Project	IEEE 802.16 Broadband Wireless Access Working Group < http://ieee802.org/16 >	
Title	Modification of Open loop STC	
Date Submitted	2004-03-16	
Source(s)	Chan-Byoung Chae, Wonil Roh, Sung-Ryul Yun, Kyunbyoung Ko, Hongsil Jeong, JeongTae Oh, Seungjoo Maeng, Panyuh Joo, Jaeho Jeon, Jerry Kim, Soonyoung Yoon, K. Sivanesan, Marcos Katz, DS Park	cb.chae@samsung.com
	Samsung Electronics Co., Ltd.	
	Jianzhong (Charlie) Zhang, Anthony Reid, Kiran Kuchi, Heikki Berg, Nico Van Waes	Charlie.Zhang@nokia.com
	Nokia Research Center	
Re:		
Abstract	Modification of the open loop STC for 3, 4 Tx	
Purpose	Adoption of proposed changes into P802.16e	
	Crossed out indicates deleted text , <u>underlined blue indicates new text change to the Standard</u>	
Notice	This document has been prepared to assist IEEE 802.16. It is offered as a basis for discussion and is not binding on the contributing individual(s) or organization(s). The material in this document is subject to change in form and content after further study. The contributor(s) reserve(s) the right to add, amend or withdraw material contained herein.

Modification of Open loop STC

Fig 1. An example of the choice of subscript k to determine the Matrix A.

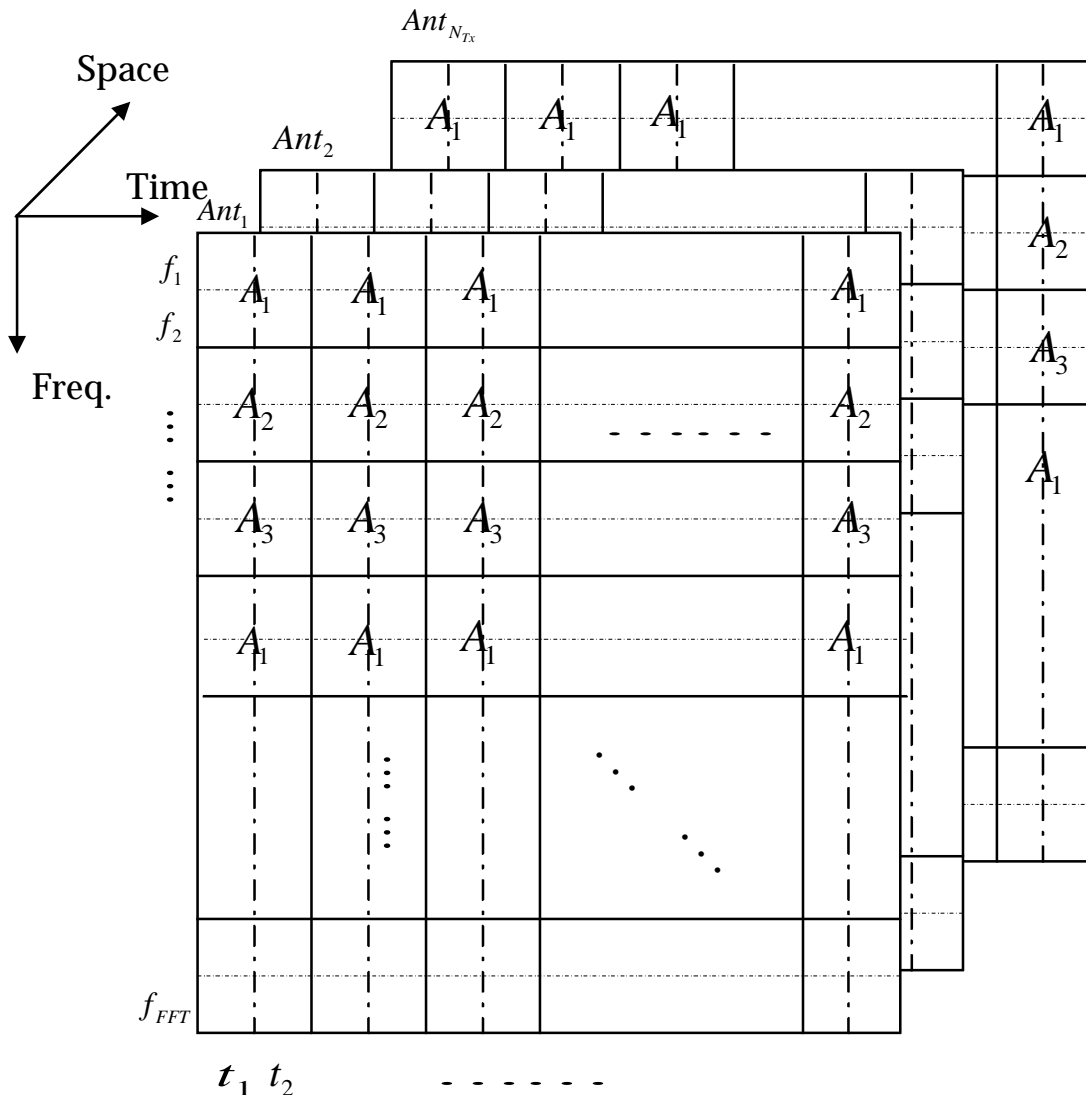
Since, there are space-time-frequency codes (over two OFDMA symbols and two sub-carriers) in [1], we propose a modification of the 3 Tx antenna STC for rate 1 and 2, i.e., Matrix A, Matrix B, should be changed to:

$$k = \text{mod}(\text{floor}(((\text{logical_data_sub_carrier_number_for_first_tone_of_code} - 1) / 2), 3) + 1$$

In addition, the above equation can be applied to the 4Tx antenna rate 1 (Matrix A).

where, logical_data_sub-carrier_number_for_first_tone_of_code = 1, 2, 3, ..., total number of data subcarriers.

~~In optional FUSC zones, †~~The index k , of permuted version of Matrix A and B to use for a particular deployment is given by : ~~$k = \text{mod}(\text{logical_data_sub-carrier_number_for_first_tone_of_code}, 3) + 1$~~ $k = \text{mod}(\text{floor}(\text{logical_data_sub-carrier_number_for_first_tone_of_code-1)/2), 3) + 1$, where logical_data_sub-carrier_number_for_first_tone_of_code=1,2,3,..., Total # of data sub-carriers.
